## *City of Afton*

### **Natural Resources and Groundwater Committee (NRGC)**

Re: Will Carlson Sketch Plan for a Preservation and Land Conservation Development (PLCD) Subdivision for 218 acres of Land Located on 60<sup>th</sup> Street West of Trading Post Trail.

RE: Pre-Draft EAW for 60<sup>th</sup> Street Carlson PLCD (Carlson PLCD)

#### DNR Comments

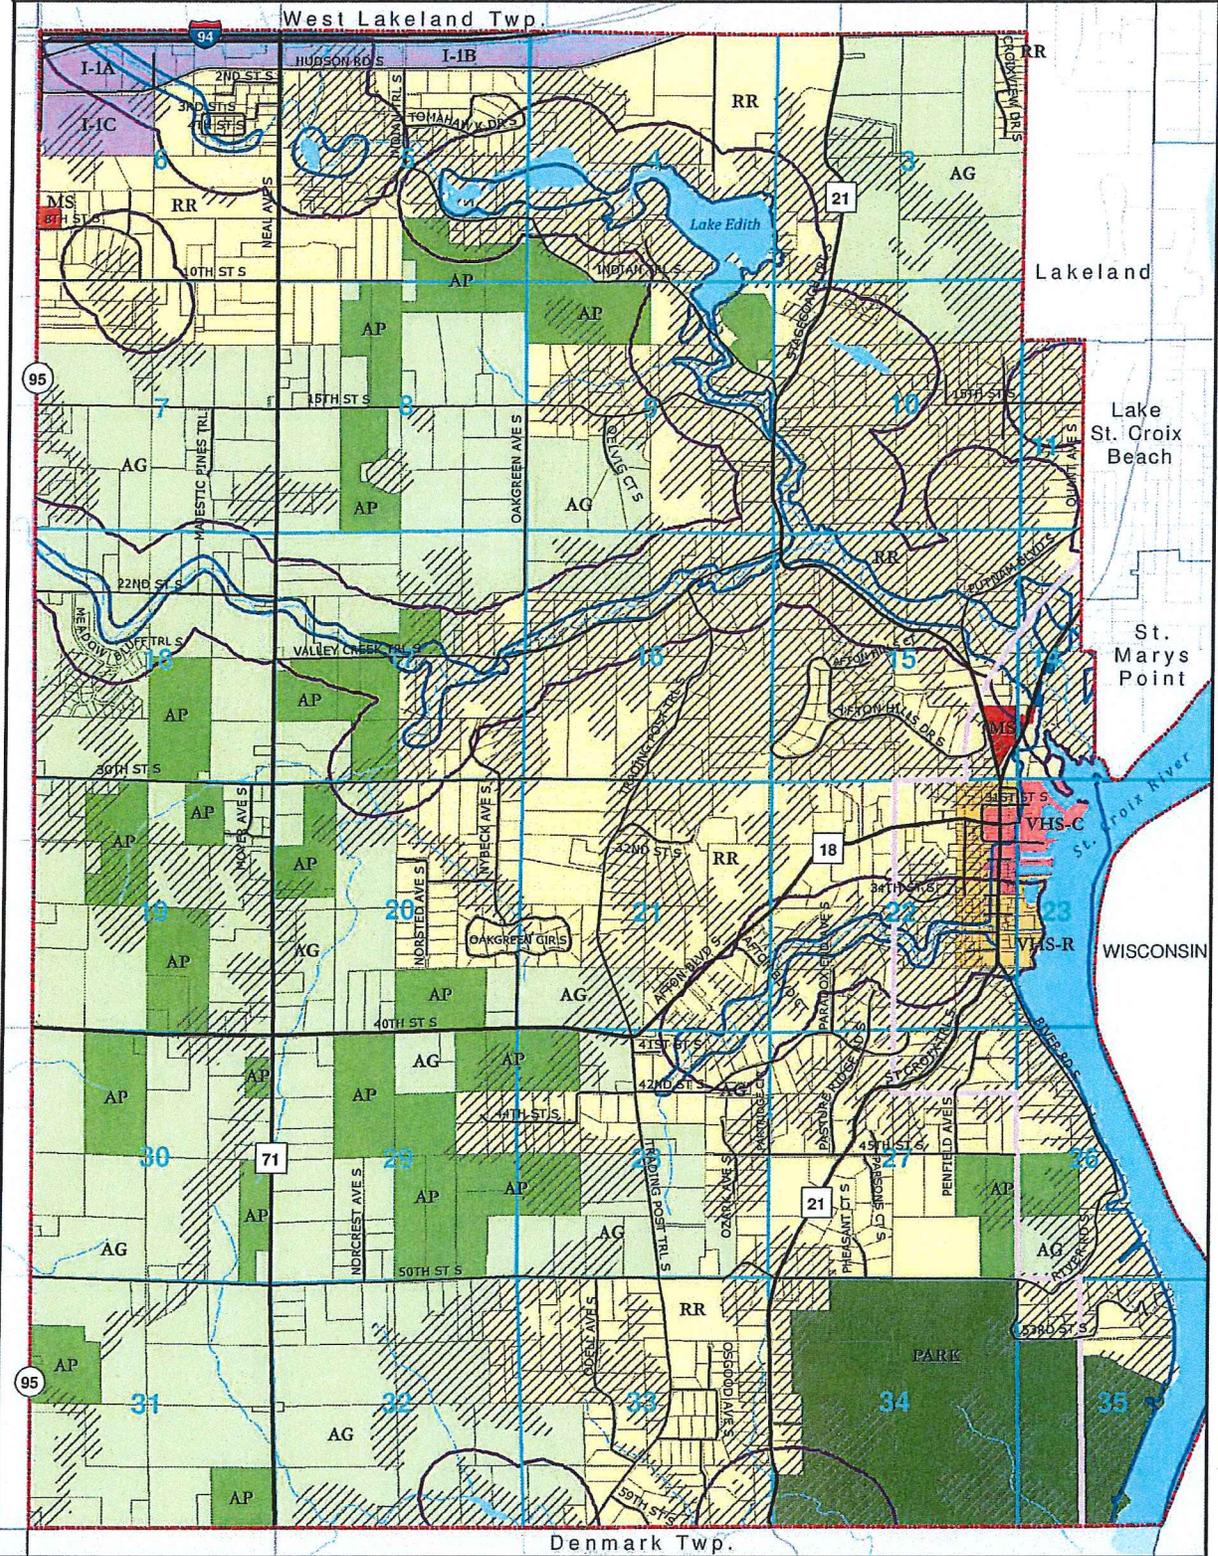
Based on the DNR comments summarized below, and the City's ability to protect steep slopes with a scenic easement, the Committee may want to focus its consideration of modifications to the site plan on the area near the stream rather than the areas of steep slopes in the northeast portion of the site.

Jen Sorenson, East Metro Hydrologist for the DNR, has indicated that when a planned unit development, such as the Carlson PLCD, involves preserving open space along a stream, the DNR prefers that the open space includes the land within the Shoreland Management Area of the stream, which is the area that is outlined on the City's Zoning Map (see attached). Otherwise, the DNR's review of the proposed development will need to include a more detailed review of the impacts on and protection of the stream. Ms. Sorensen also referenced that the stream is groundwater supported and the protection of the groundwater recharge area for the stream is important.

# PRESERVATION & LAND CONSERVATION DEVELOPMENT - SKETCH

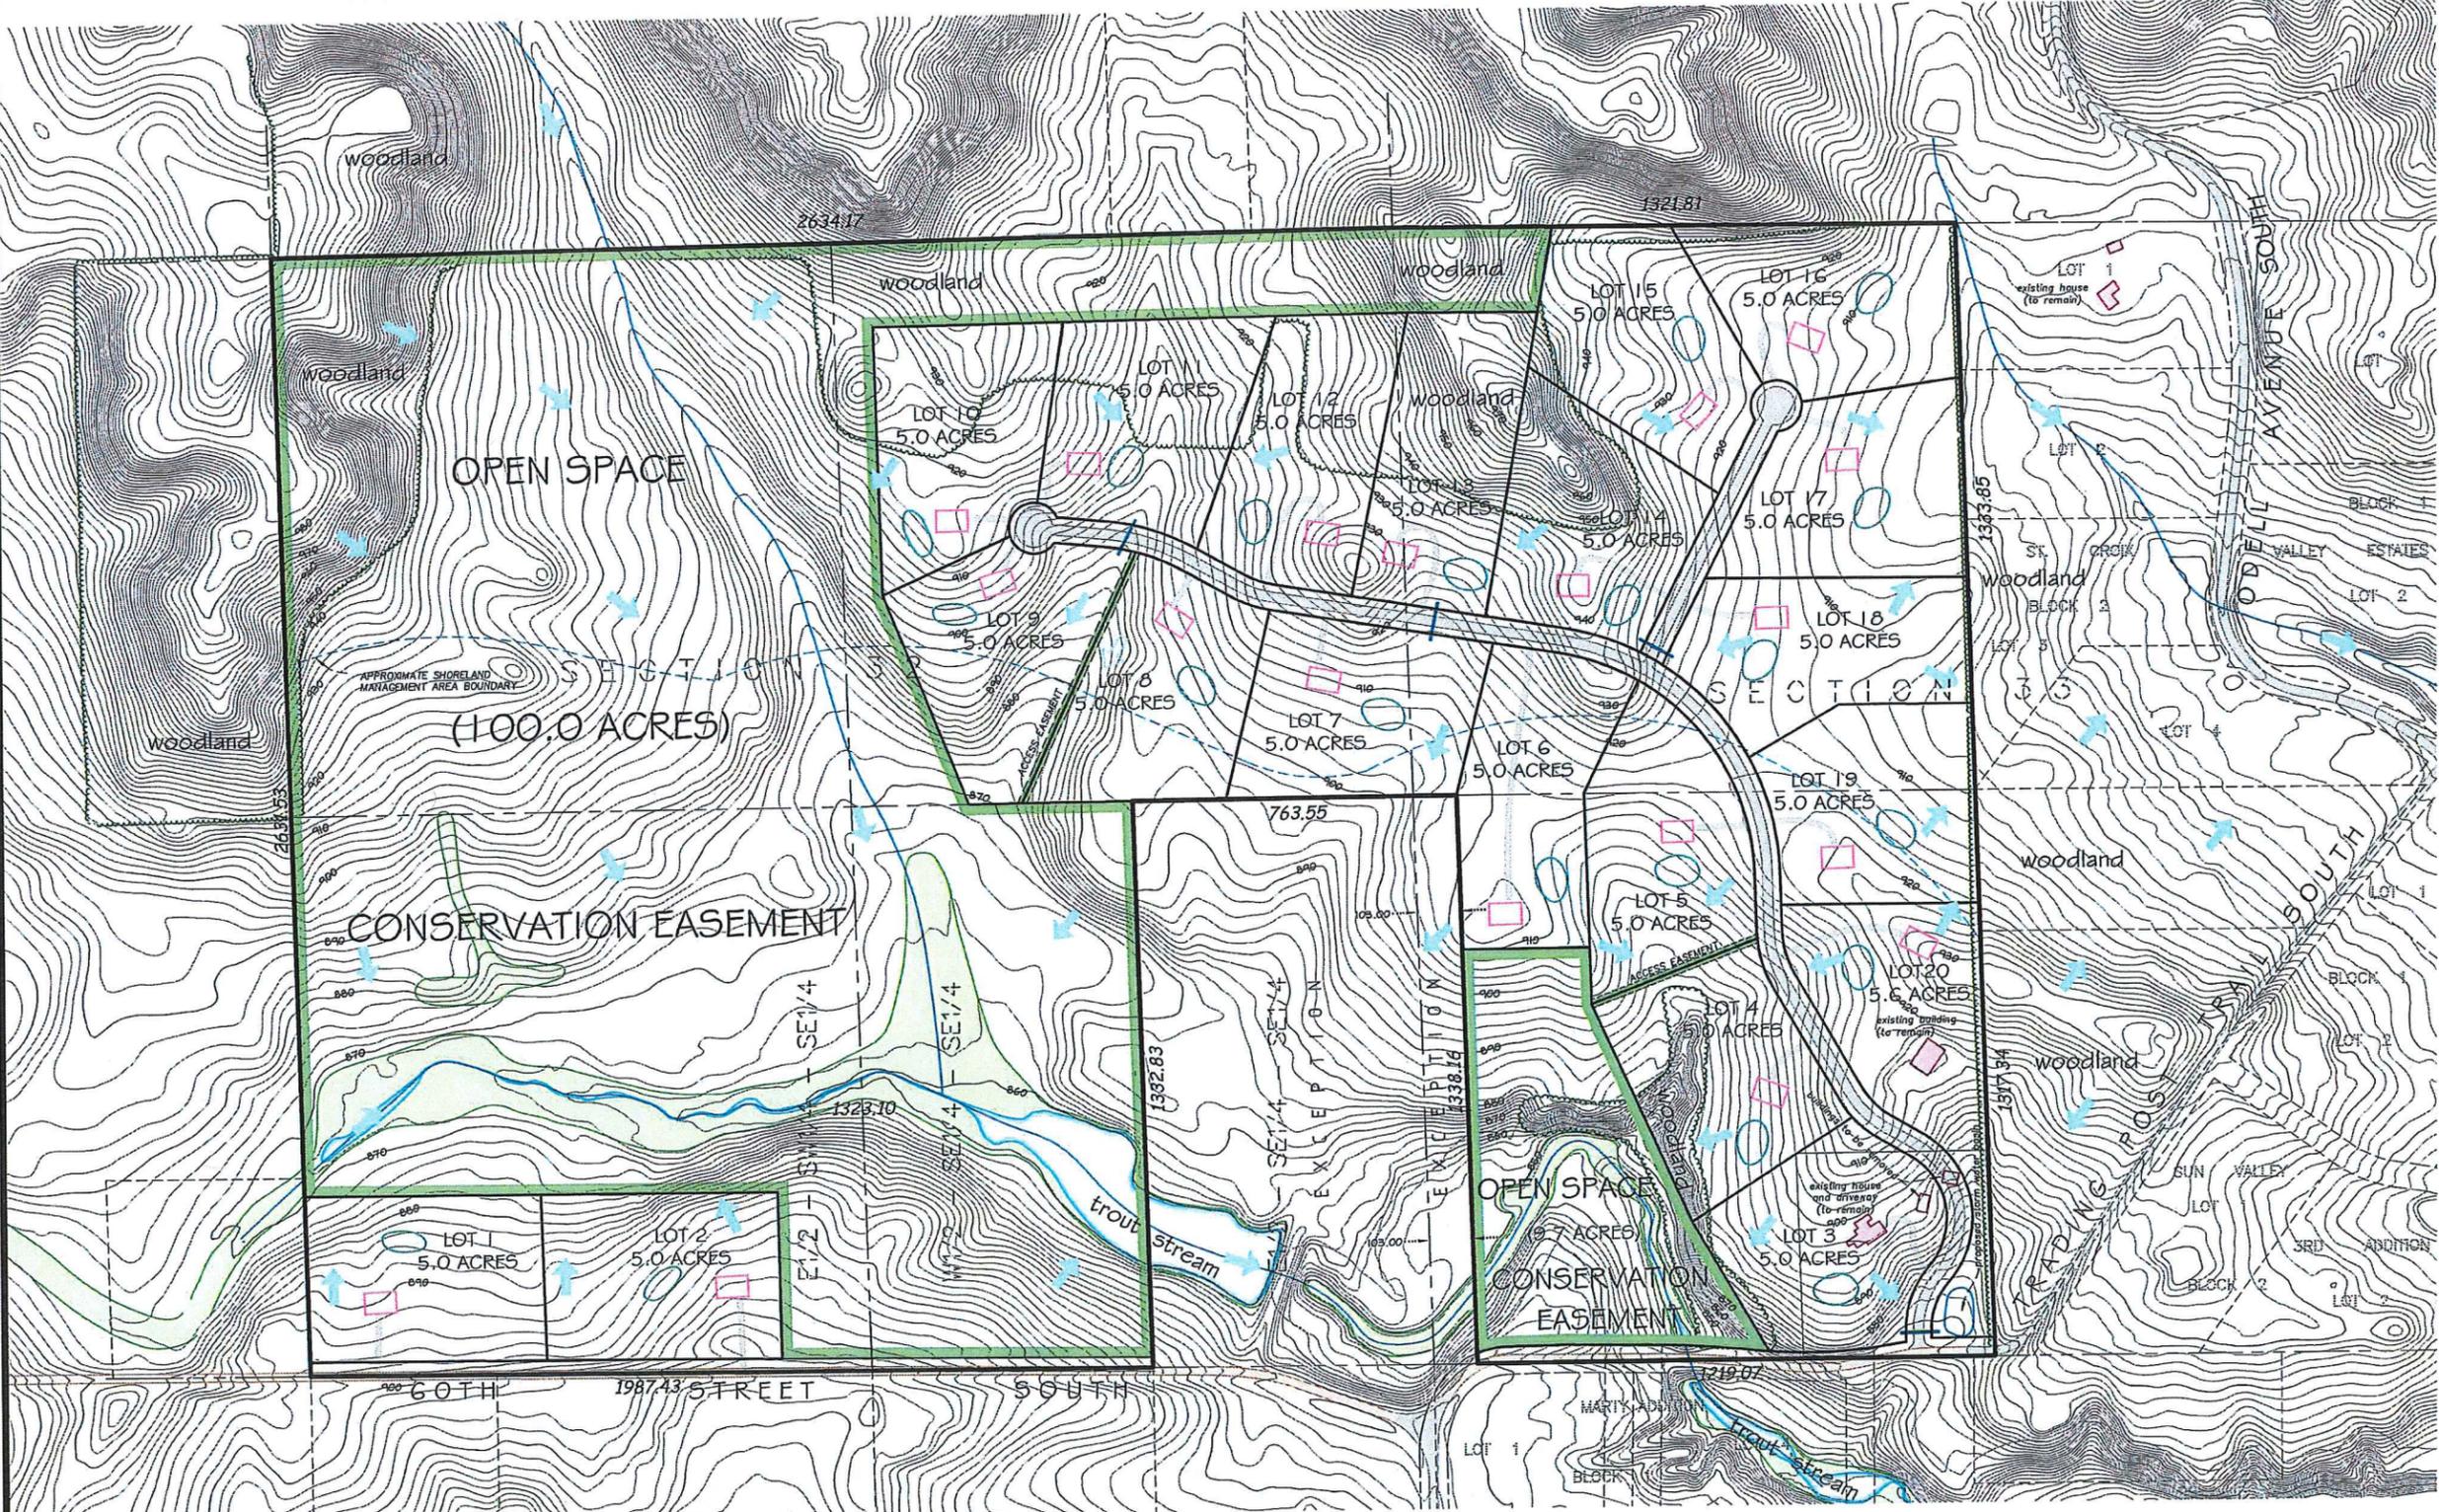
The EAW references no storm water pond yet the Sketch Plan attached to the EAW shows PLCD Lot 3 has a storm water pond.

10.b. Geology, soils, topography and land forms. Half the site has soil types that have a “severe” erosion hazard ranking according to the USDA soil maps included in EAW Figure 7. PLCD Lots 3, 4, 10, 13, and 14 appear to be completely within the area identified with a “severe” erosion hazard suggesting they do not have the required 2.5 acres of suitable building area. Development on these fragile soils presents a substantial environmental risk and requires aggressive erosion control measures. This is of particular immediate concern because much of the land has had a cover crop during the growing season in the past. The development should install a native grass cover crop in Spring of 2017 to minimize erosion. See also 9.c. above.

*Bake Baker's  
Layout modifications*

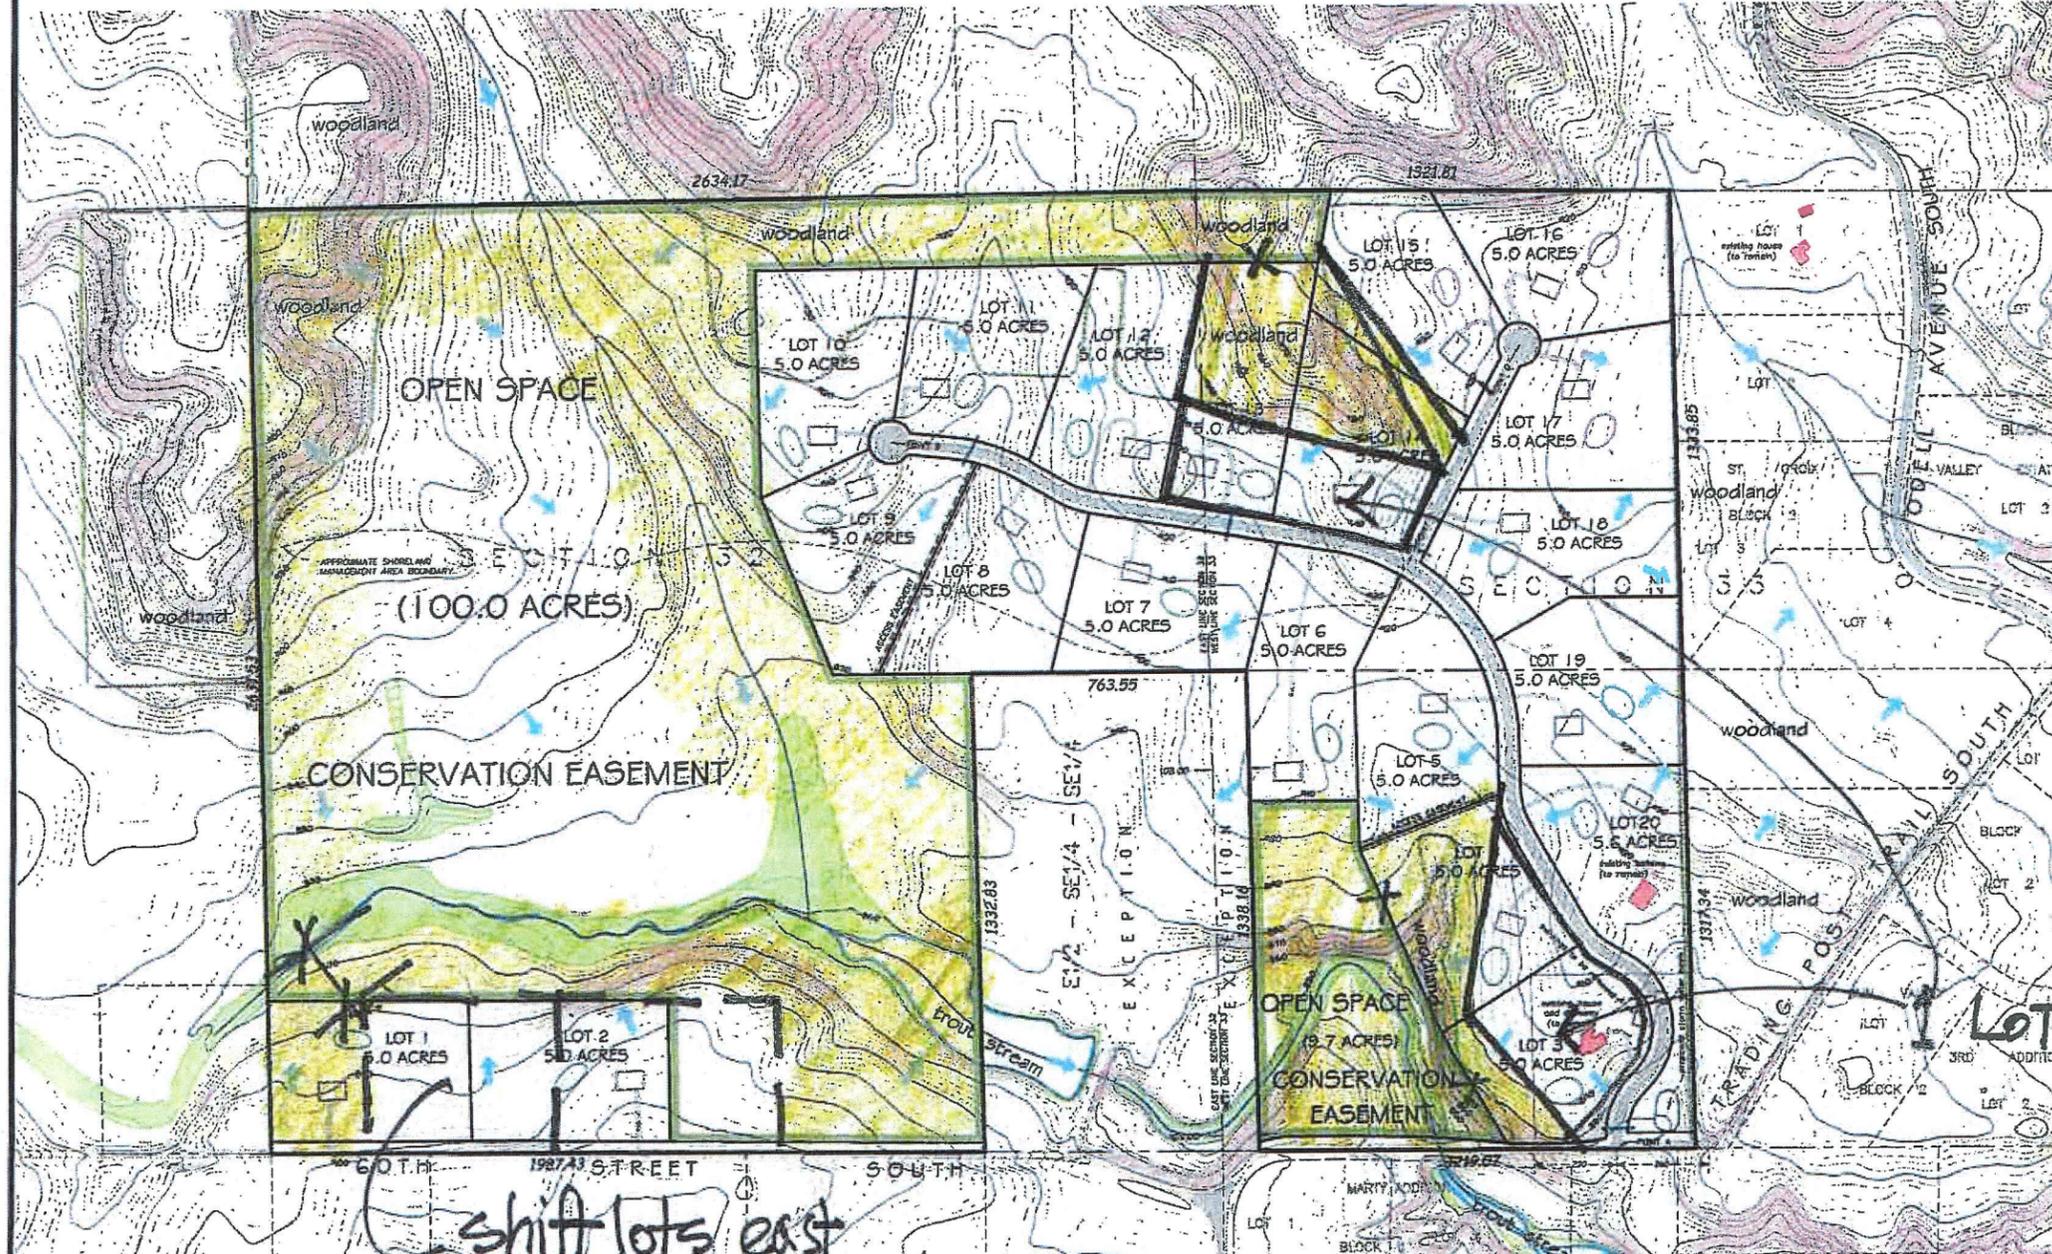
After reviewing the proposed site plan, the draft EAW, and thinking about the steep slopes and trout stream proximity, Bake Baker is suggesting some minor modifications to the site plan. Attached is a mark-up of the site plan. It shows a shift of the lots in the southwest corner of the site in a slightly easterly direction to move the northwest corner of the lots

away from the stream. On the other portion of the site, it eliminates 2 lots by consolidating 4 into 2 and adding the steep-sloped portions to the open space conservation easement area.

*shift lots east  
away stream edge*

- on-site/on-parcel stormwater mgmt. - 2 Lots
- lot revision (- 2 lots)
- water quality/water detention • buffer

9.c. Approximate location of start of drainage channel created by overland flow from Carlson property

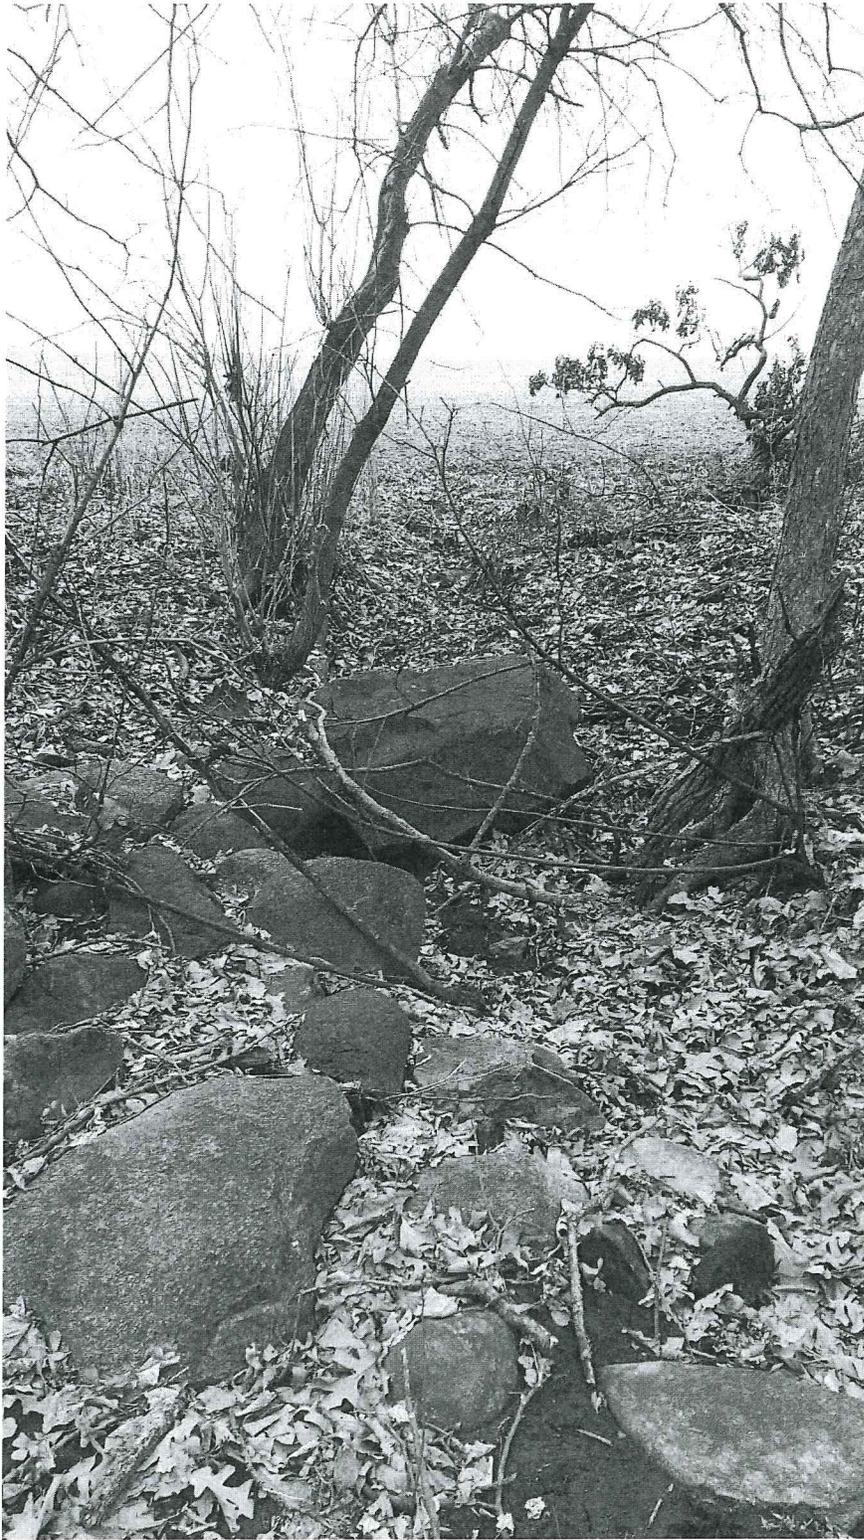
9.c. Landuse. The EAW identifies yard overland sheet flow as a concern and states that vegetative buffer strips to address erosion and rainfall will be planted on Lots 1-10 and 16-17. As mentioned several times before, overland sheet flow drainage during snowmelt and heavy rainfalls currently presents a drainage problem on existing properties to the east of the project site and adjacent to proposed PLCD Lots 18, 19, and 20. These adjacent properties border Odell Avenue and are located at 5650 and 5550 Odell.

Drainage from the Carlson property flows downhill and overland to a low point on the boundary line with these adjacent properties at the eastern edge of PLCD Lot 18 and 19. The erosion from this runoff has cut a drainage channel at this intersection as it flows east and the runoff ultimately flows in a large swath between these adjacent properties during snowmelt and heavy rainfall. Rocks have been placed in this channel to try to prevent continuing erosion. See attached map showing approximate location and pictures showing drainage channel. The development needs to address this drainage problem and present a plan to retain its storm water on the project site. At a minimum, special vegetative buffer strips to address erosion and overland sheet flow due to rainfall and snowmelt should be added to the eastern portions of proposed PLCD lots 18, 19 and 20 to address this issue. Given the plan for a phased construction period as lots are sold, the developer should be required to plant these strips immediately to address this ongoing problem. The drainage problem will be aggravated if this is not addressed immediately because the project site has always had cover crops on it during the growing season which reduced erosion and runoff. If the site remains unplanted, erosion and runoff onto adjacent properties to the east will be increased.
